# Service Bulletin

NO. 350

SOUTH BEND 27, INDIANA

*Studebaker and  
Packard*

FIG. 1

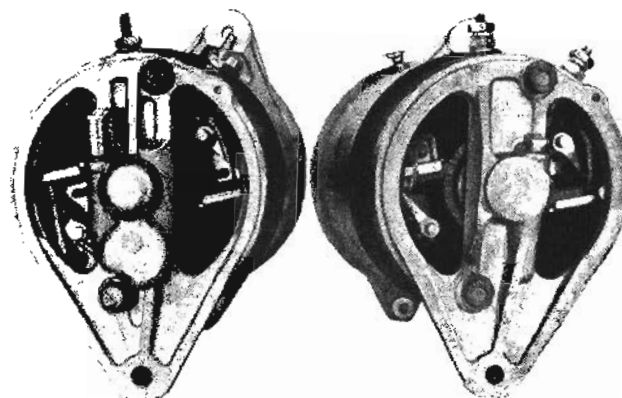
An improved design generator commutator end plate entered late production of 1959 - V8 models. The latest plate, illustrated on the left in Figure 1, can be identified by the larger oil reservoir located below the bearing area. This end plate, Part No. 1544188, available for service installation incorporates the larger type oil reservoir.

In case of commutator end plate bearing failure on early production 1959 models, in addition to installation of the end plate, Part No. 1544188, a new armature, Part No. 458827, should be installed, if there is any evidence of damage to the armature.

2 DOOR SEDAN  
FIG. 2

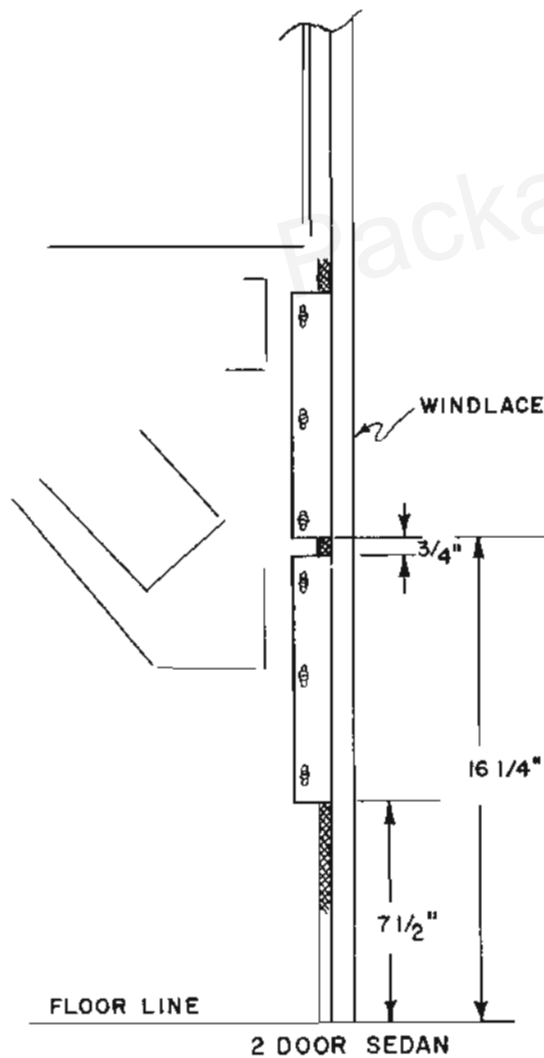
Windlace metal retainer plates have been released for installation on the 1959 models. The Retainer, Part No. 1334049, effectively holds the windlace in place on the center door post of 4-door models and on the quarter panel door post on the 2-door models. Four retainers are required, two retainers at each post.

Remove the rear quarter trim panel and locate the lower edge of one plate 7 1/2" from the floor pan and the bottom of the second plate 16 1/4" from the floor pan. (See Fig. 2 .)

With the windlace properly positioned, install each retainer plate next to the windlace cord with 3 small sheet metal screws. The flanged edge of the retainer plate should face the door post. Make sure the retainer plates do not extend beyond the front edge of the door post.

4 DOOR SEDAN  
FIG. 3

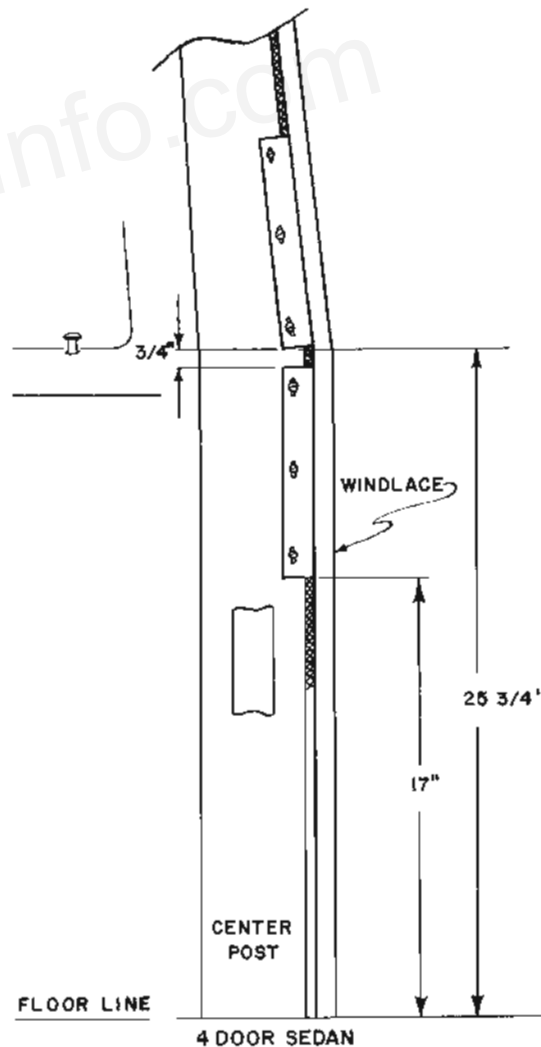
Carefully remove the door post trim panel by inserting a wide blade screw driver behind the trim panel at each drive nail location and pry the trim away from the post. The end of the screw driver should be placed between the drive nail trim retainer washers and the retainers in the post. The lower edge of one plate should be located 17" from the floor pan and the bottom of the second plate 25 3/4" from the floor pan. ( See Fig. 3 . )
